GROUP	MODEL
ELE	2015-2017MY Soul EV (PS EV)
NUMBER	DATE
310 (Rev 1, 05/07/2024)	October 2023

TECHNICAL SERVICE BULLETIN

HIGH-VOLTAGE BATTERY PACK AND BATTERY MANAGEMENT SYSTEM

This bulletin has been revised to include additional information. New/revised sections of this bulletin are indicated by a black bar in the margin area.

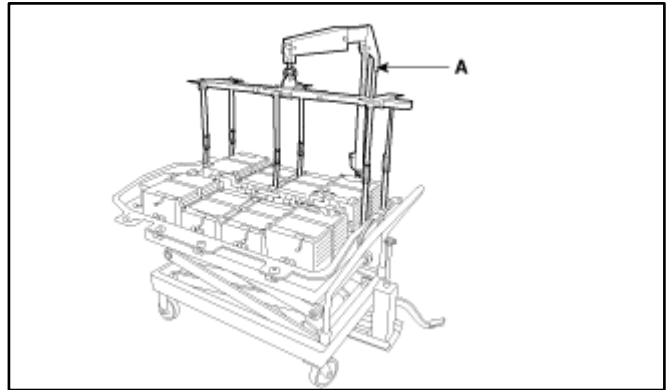
15-17MY ONLY new PN BPA is equipped with a "new" type harness. **(Rev 1) removed swap harness.**
